Government of the District of Columbia
Department of Transportation

MEMORANDUM

DATE: March 25, 2019

SUBJECT: ZC Case No. 06-10D – Art Place Block B

O:\PROJECTS\7501 - 8000\7611 ART PLACE PHASE II\PLANS\3.13.19 AUTOTURNS\C&A ART PLACE AUTOTURNS.DWG

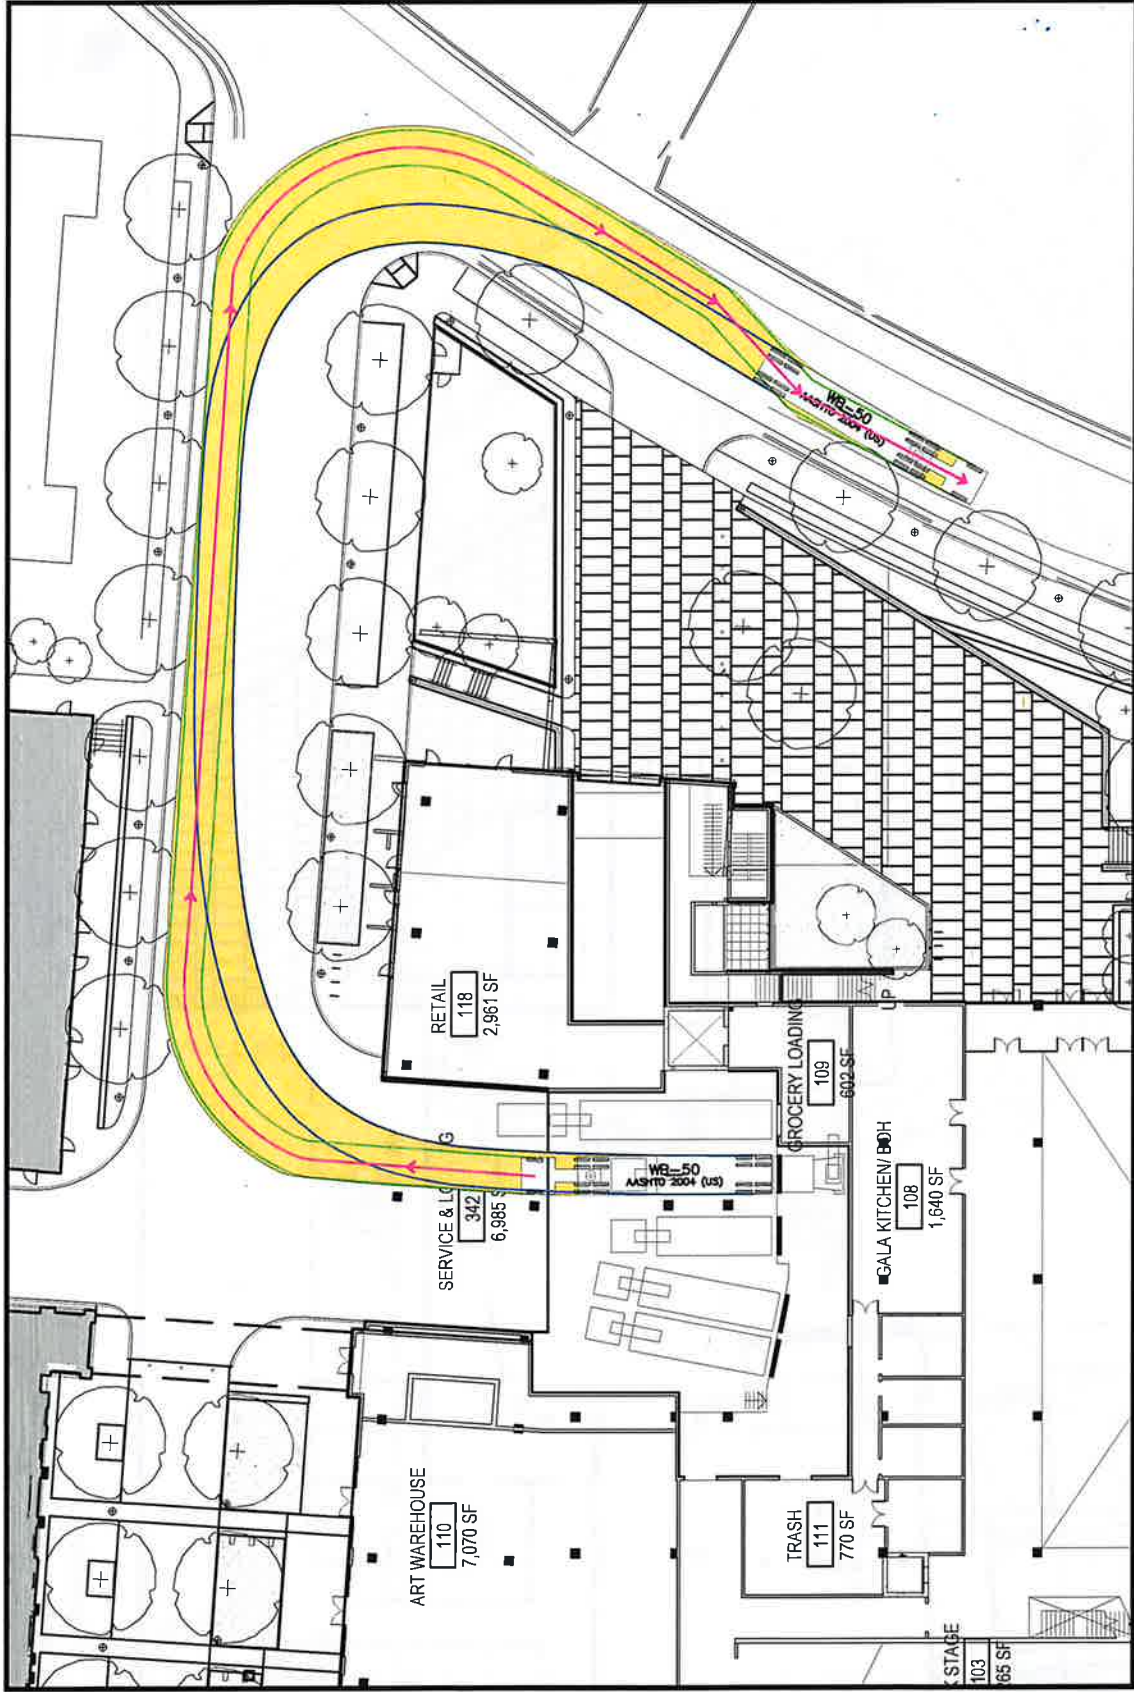
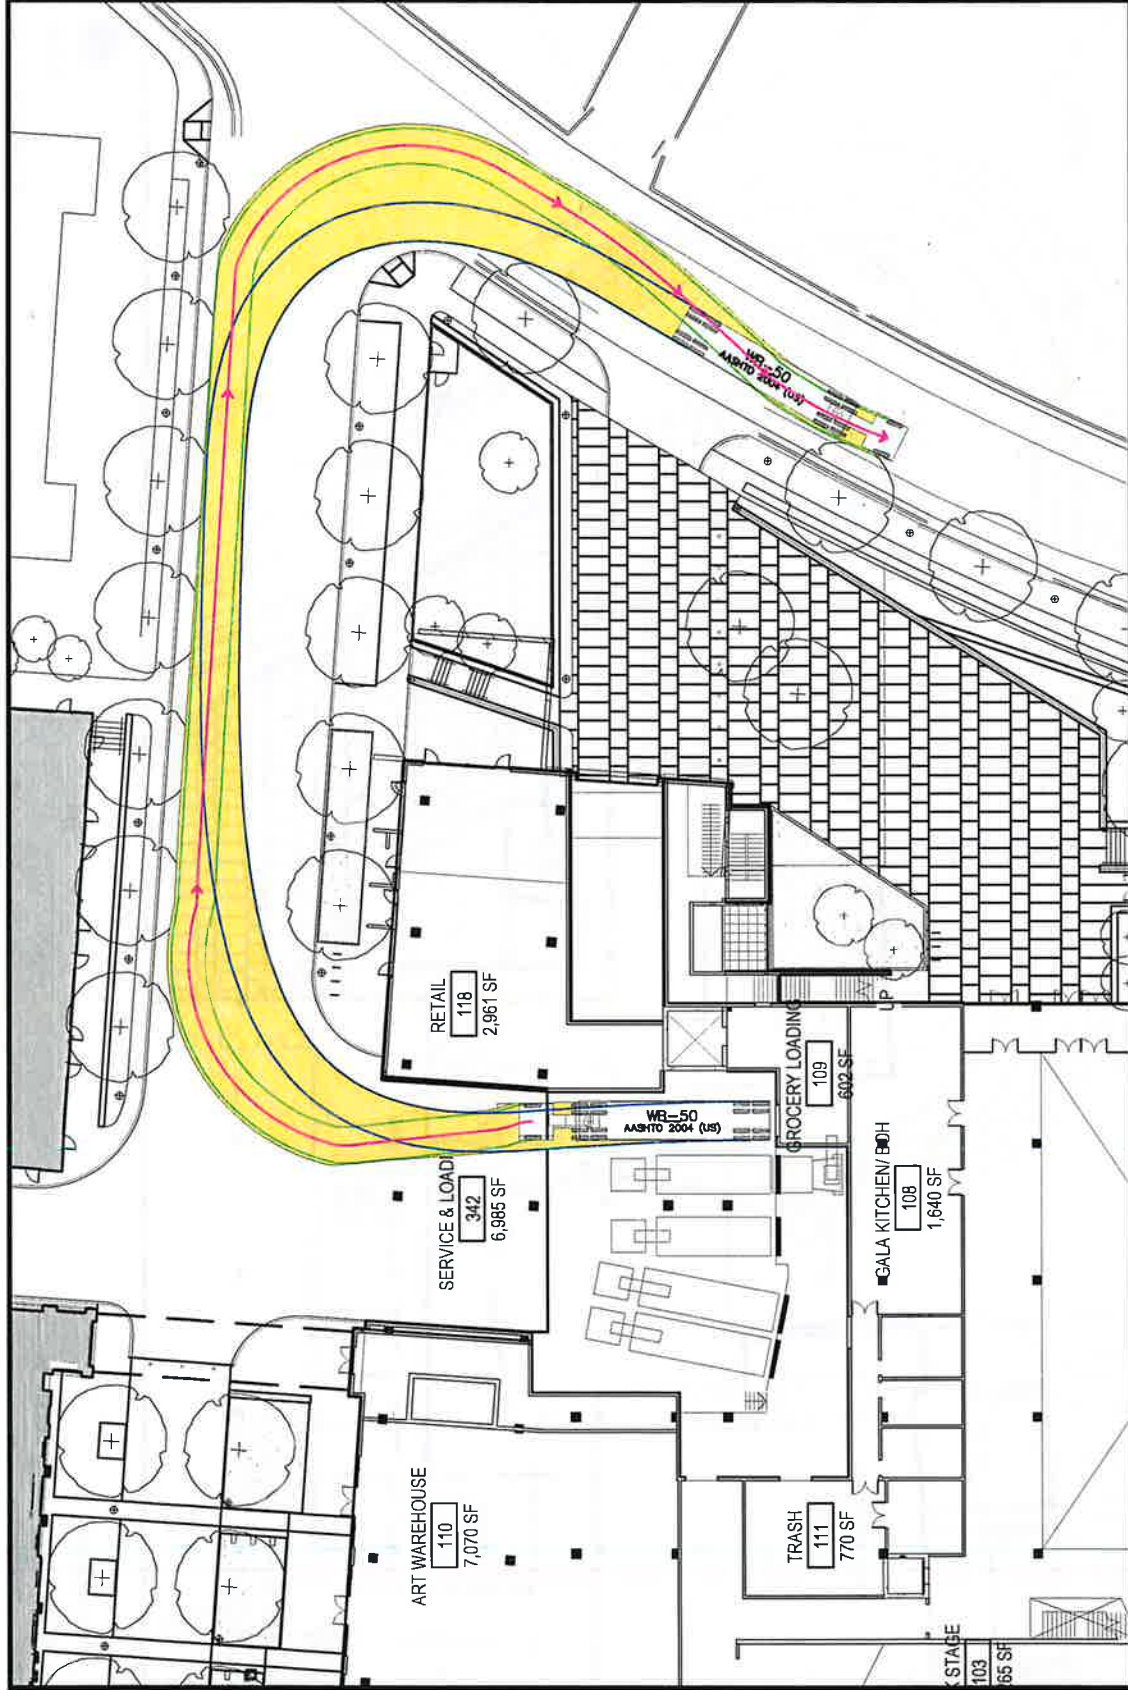
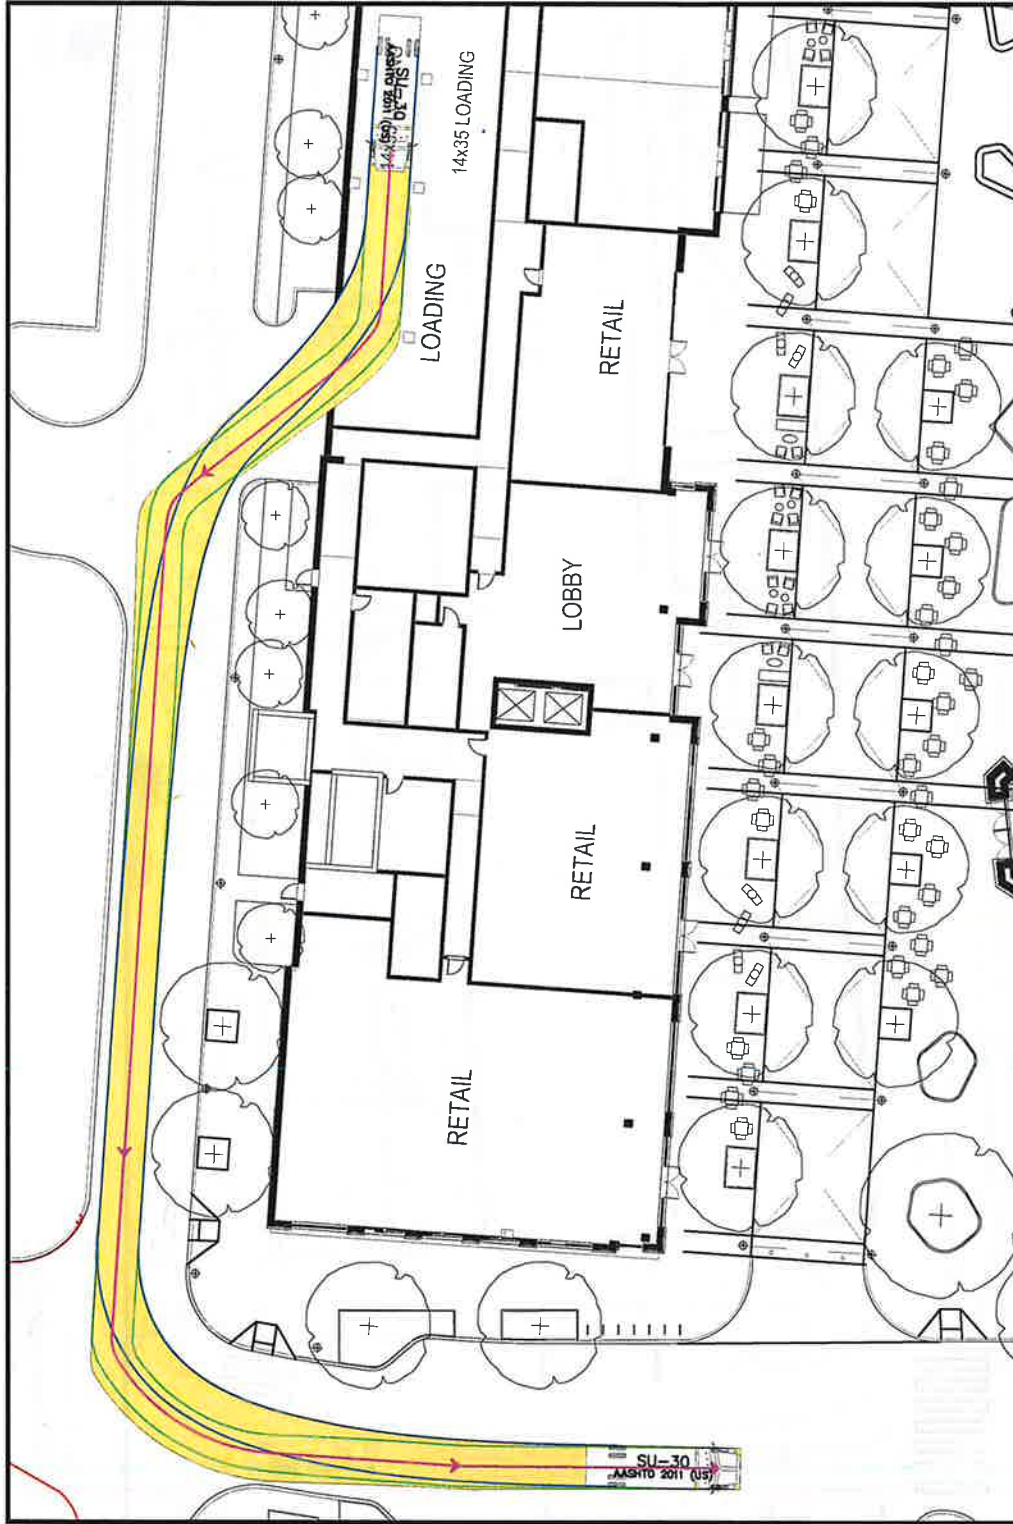
Comment #6: *In Appendix I, there are several instances of trucks clipping corners and going over curbs, even on the private street. Also, since Kennedy Street will be realigned in the future, the analysis should be done with that future alignment. On page I-12, you'd need to restrict parking on Kennedy to make the turn, so you'll need to discuss in your analysis how and when that parking would be restricted.*

Response: Updated swept area diagrams are provided in Attachment 2. The truck size for the site has been reduced to SU-50 for the commercial uses in the eastern building and SU-30 for the residential uses in the western building. A revised Loading Management Plan is included as Attachment 3. Loading for the western building via the public alley would no longer encroach on the parking area on Kennedy Street prior to entering the alley.

The Kennedy Street alignment has not yet been fully designed; therefore, it would be difficult to provide detailed truck turning diagrams on the future alignment. At the time that the realigned roadway is designed, trucks will be accommodated with appropriate curb radii and roadway widths.
